CERTIFICATE OF APPROPRIATENESS

Application Number: HDC2026-00018

Project Address: 4324 (4314-4316) W. Vernor

Historic District: Hubbard Farms

Front View South Wall

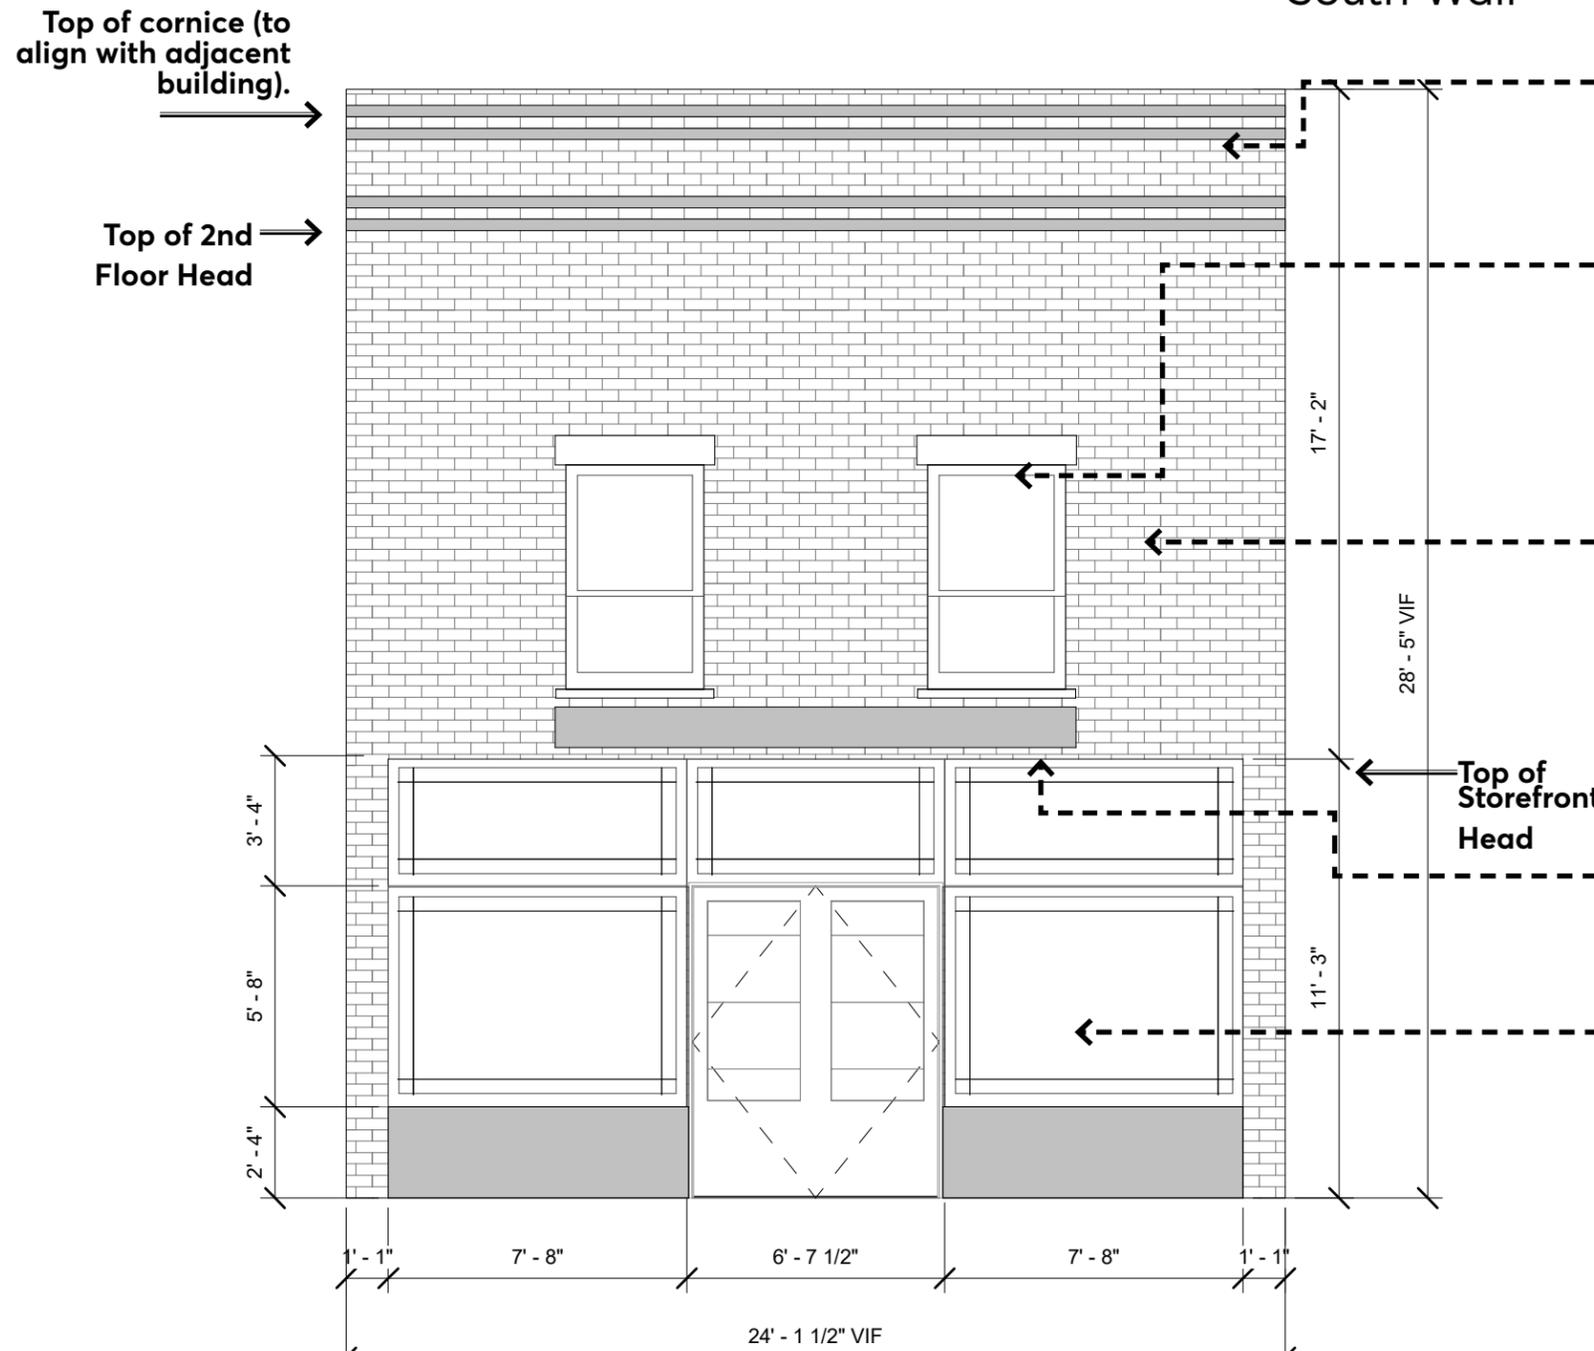
- The brick selection will be submitted to staff for review and approval. The brick size needs to match the historic.
- The parapet will be as tall as its historic height.
- The glazed banding will be returned to its original location.
- The proposed storefront system, including the doors, signage, dimensioned drawings and specifications, shall be provided to staff for final approval.
